Groundwater Application Review Summary Form

Application # G- 18298 Re-Review GW Reviewer <u>James Hootsmans</u> Date Review Completed: 8/1/2025 **Summary of GW Availability and Injury Review:** ☐ Groundwater for the proposed use is either over appropriated, will not likely be available in the amounts requested without injury to prior water rights, OR will not likely be available within the capacity of the groundwater resource per Section B of the attached review form. **Summary of Potential for Substantial Interference Review:** There is the potential for substantial interference per Section C of the attached review form. **Summary of Well Construction Assessment:** The well does not appear to meet current well construction standards per Section D of the attached review form. Route through Well Construction and Compliance Section. This is only a summary. Documentation is attached and should be read thoroughly to understand the basis for determinations and for conditions that may be necessary for a permit (if one is issued).

Application G-18298 Re-Review

Well Statistics

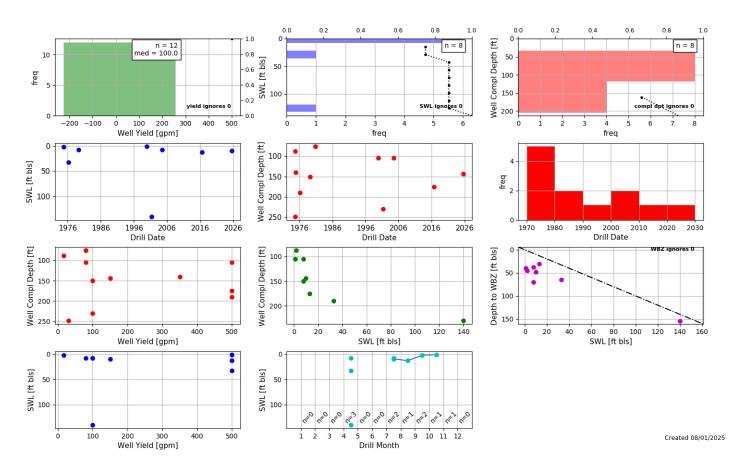
The proposed rate is 0.288 cubic feet per second (cfs) which is approximately 129 gallons per minute (gpm). Well statistics of 12 wells in T1S 33 E sections 5, 6, 7 and 8 indicate that the median well yield is 100 gpm and the maximum is approximately 500 gpm (see Well Statistics below). Therefore the proposed use is within the capacity of the resource.
